Memorandum

Subj: Mediterranean Village – Coral Gables, Florida

Responses to Outstanding Transportation/Parking Items

ATTACHMENT D: SUPPLEMENTAL INTERSECTION ANALYSIS PONCE DE LEON BOULEVARD AT MALAGA AVE/UNIVERSITY DRIVE

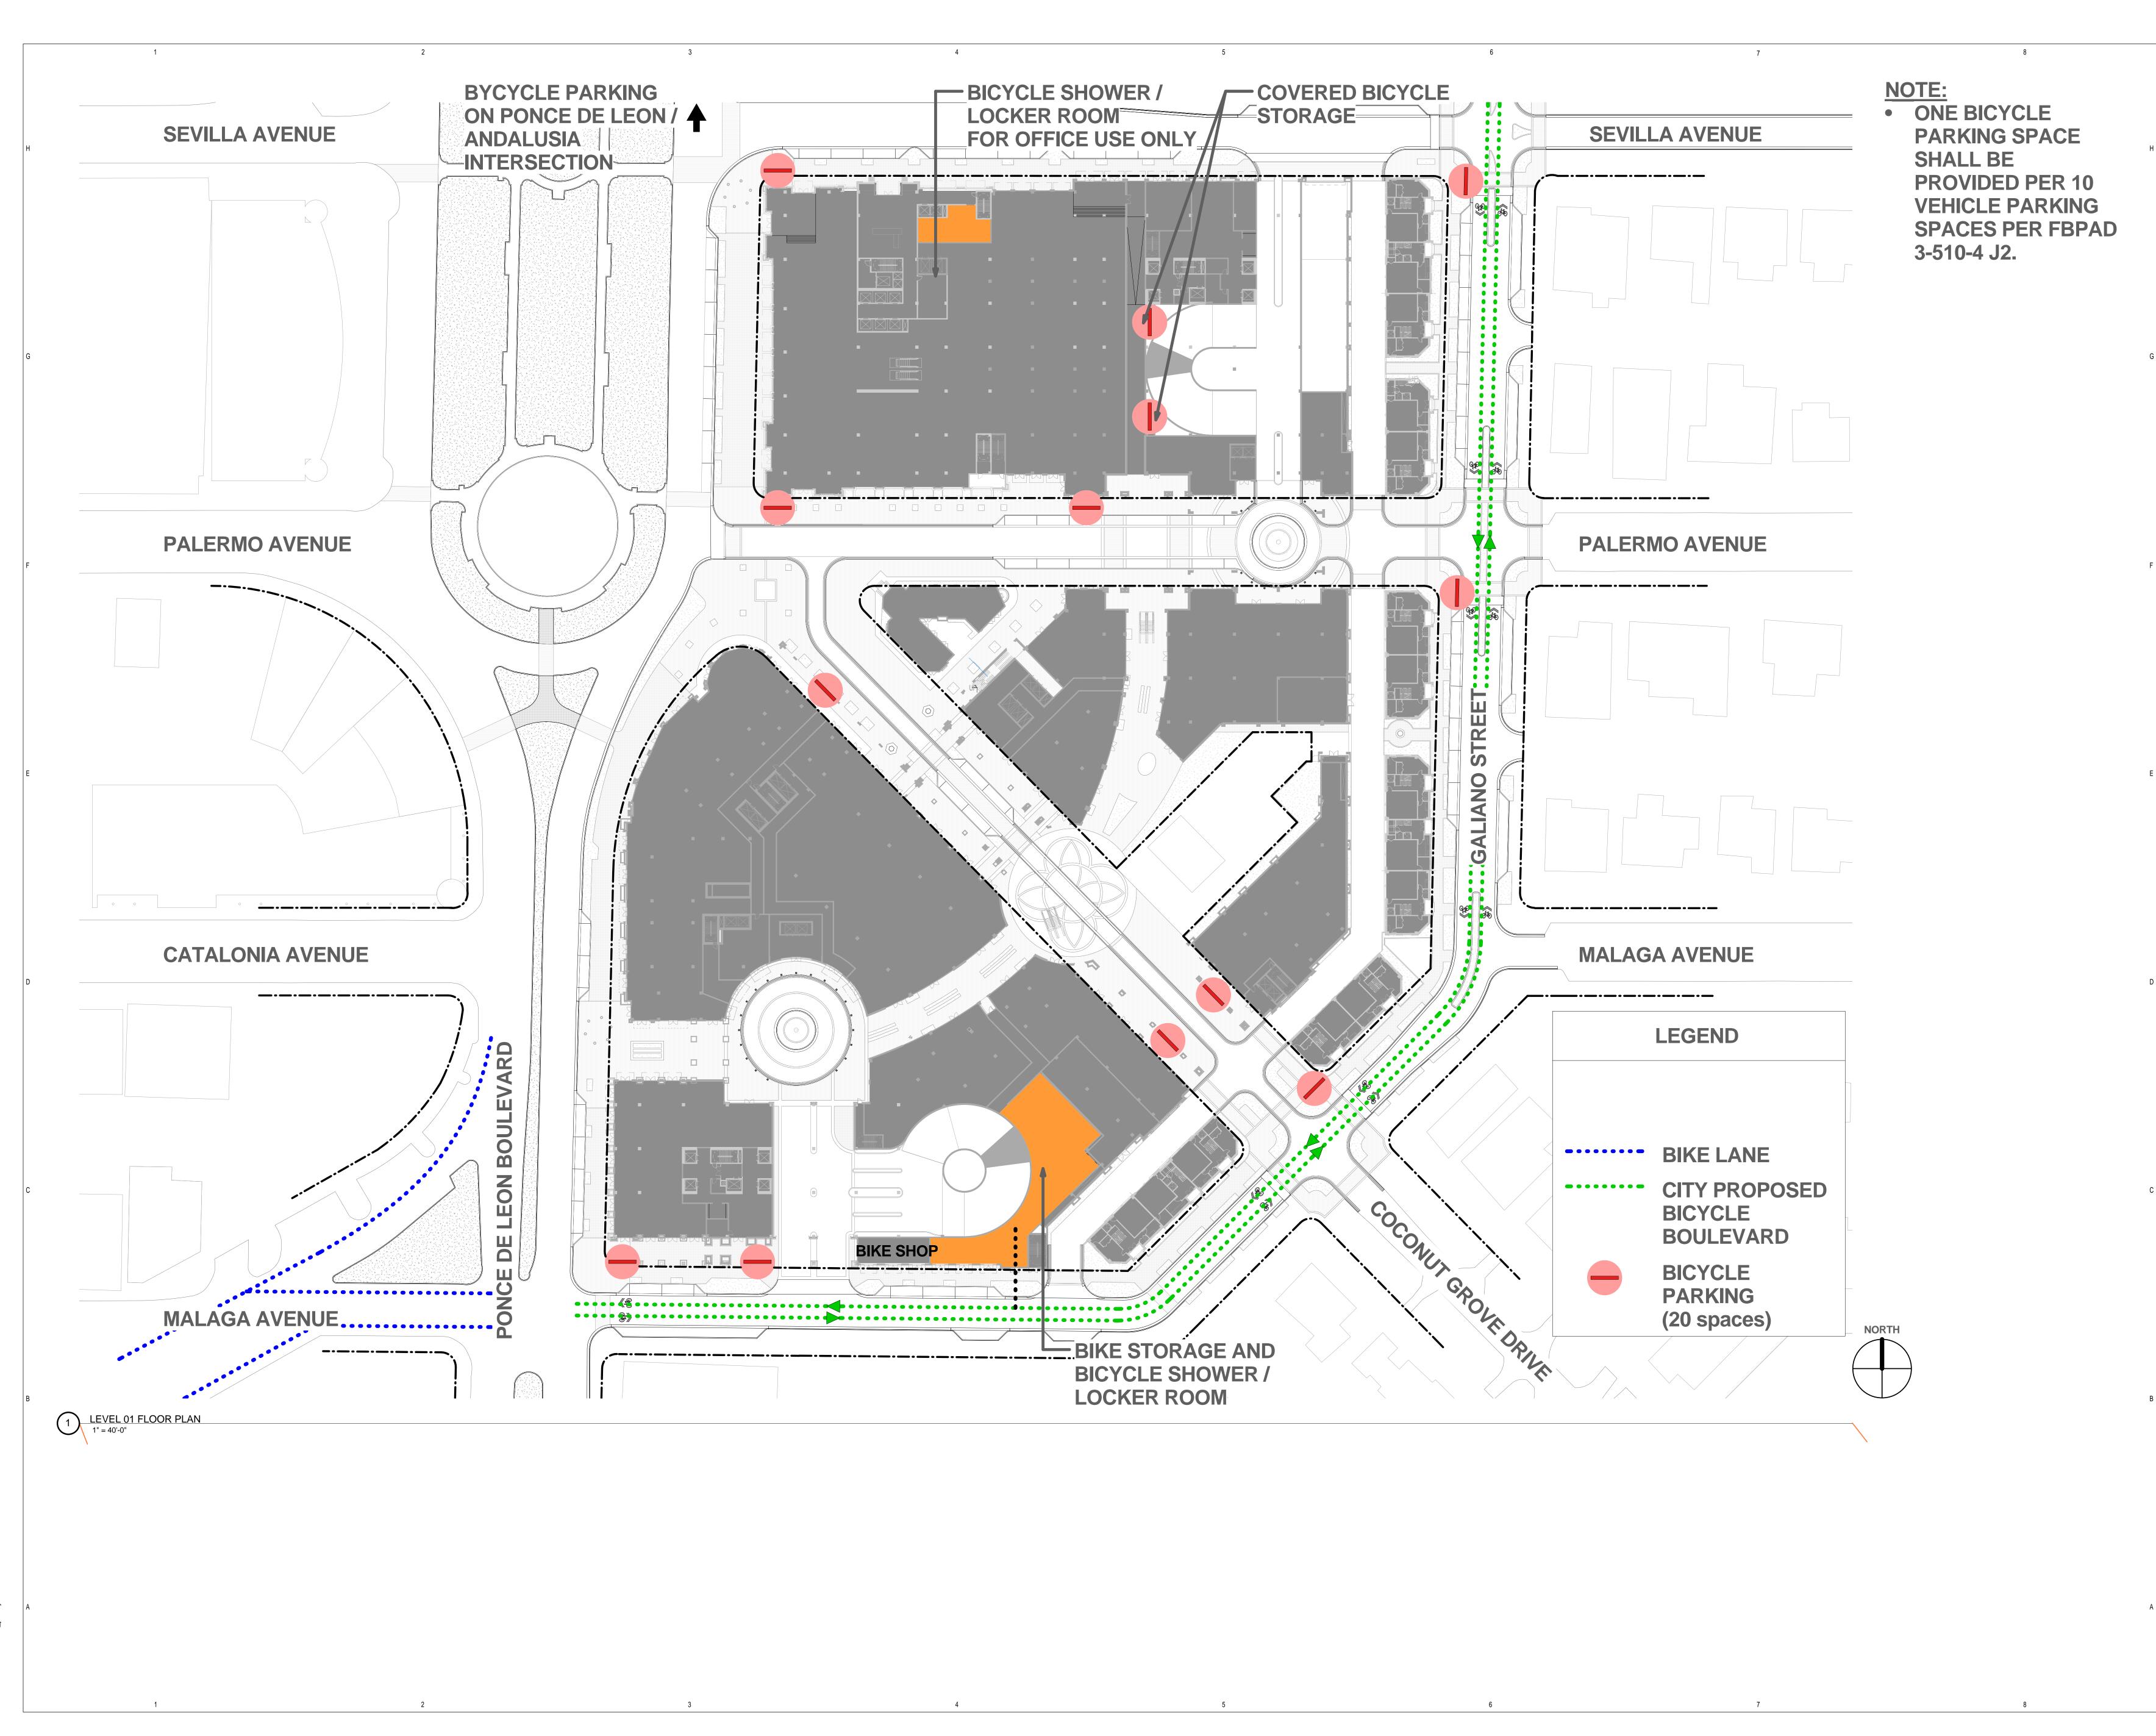
6. Roadway Improvements at Ponce De Leon Boulevard/Malaga Avenue/University Drive

At the request of both Miami-Dade County's Traffic Engineering Division and the City Public Works Department, Kimley-Horn proposed roadway geometric improvements to eliminate the existing east-west traffic signal split phasing operation at the intersection of Ponce De Leon Boulevard and Malaga Avenue/University Drive. These improvements included the construction of an additional eastbound left-turn lane to provide for three (3) eastbound approach lanes and the construction of an additional westbound left-turn lane to provide for two (2) westbound approach lanes. This option required the elimination of portions of on-street parking on both sides of the intersection.

City Planning and Zoning staff indicated that the construction of additional approach lanes and elimination of proposed/existing on-street parking is not desirable. Therefore, the intersection was examined again to determine the minimum improvements needed to eliminate the east-west split signal phasing. It was determined that the elimination of the eastbound left-turn movement from the outside (southernmost) lane would allow for the elimination of the split phase signal operation and would require to roadway widening.

In summary, the following options were identified that would allow for the elimination of the existing east-west split phasing while providing for an overall intersection level of service of LOS E or better:

- Option 1 Construction of an additional eastbound and westbound approach lane and to eliminate portions of on-street parking. Operational analysis results of this option were presented in our traffic impact analysis update memorandum dated May 17, 2015.
- Option 2 Reconfiguration of the existing eastbound approach to provide for an exclusive left-turn lane and a shared through/right-turn lane. This option would not require roadway widening or the removal of existing/proposed on-street parking. The operational analysis results for this option are included in Attachment D.

PONCE DE LEON BLVD/MALAGA AVE/UNIVERSITY DRIVE PROPOSED INTERSECTION IMPROVEMENTS

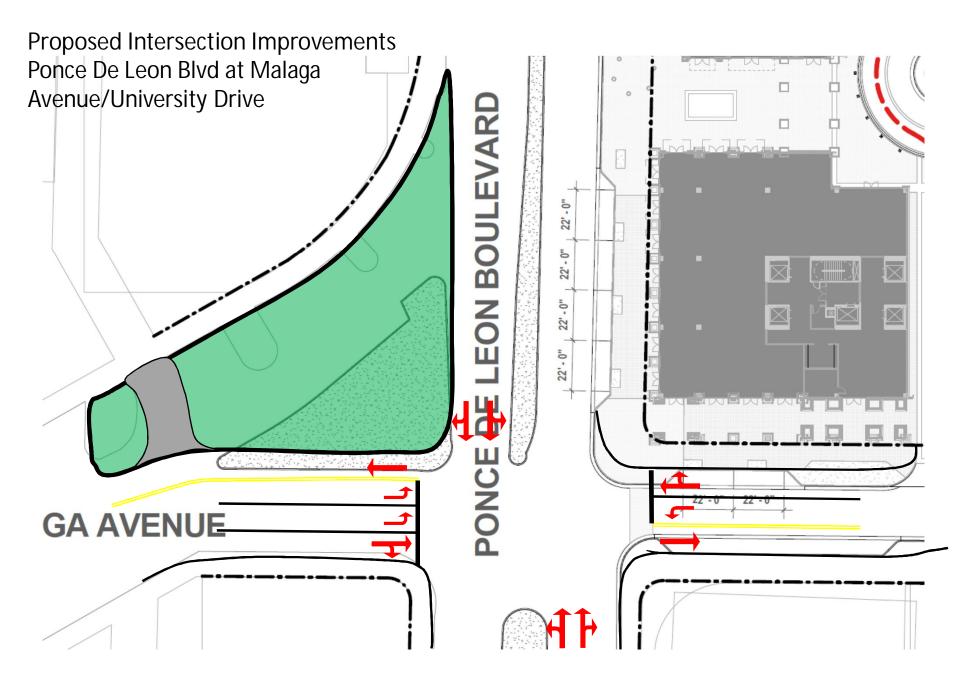
Note that currently the signalized intersection of Malaga Avenue and Ponce De Leon Boulevard currently operates with east-west split signal phasing due to the limited number of approach lanes along the minor street. At the request of both City staff and Miami-Dade County's Traffic Engineering Division staff, this updated analysis examined the impacts of geometric improvements that will allow for the elimination of east-west signal phasing. The improvements would require the following:

- Widening of the eastbound approach (west leg) to the north to provide for two (2) eastbound exclusive left-turn lanes and one (1) shared through/right-turn lane.
- Widening of the westbound approach (east leg) to the north to provide for one (2) exclusive
 westbound left-turn lane and one (1) shared through/right-turn lane. This widening will require
 the elimination of the on-street parking lane previously proposed as part of the proposed
 development.

In addition, City staff requested that the free-flowing, separated southbound right-turn movement from Ponce De Leon Boulevard to University Drive be eliminated and the right-turn movement to occur at the signalized intersection. Refer to Attachment D for a conceptual sketch of the proposed improvements. An operational analysis for the intersections of University Drive/Ponce De Leon Boulevard, Malaga Avenue/Ponce De Leon Boulevard, and South Driveway/Malaga Avenue was conducted using the same methodologies from the previous traffic impact analysis submittal. As Tables 3 and 4 indicate, all intersections are expected to operate at LOS D better under future total traffic conditions with and without the suggested improvements. Refer to Attachment E for detailed operational analysis results.
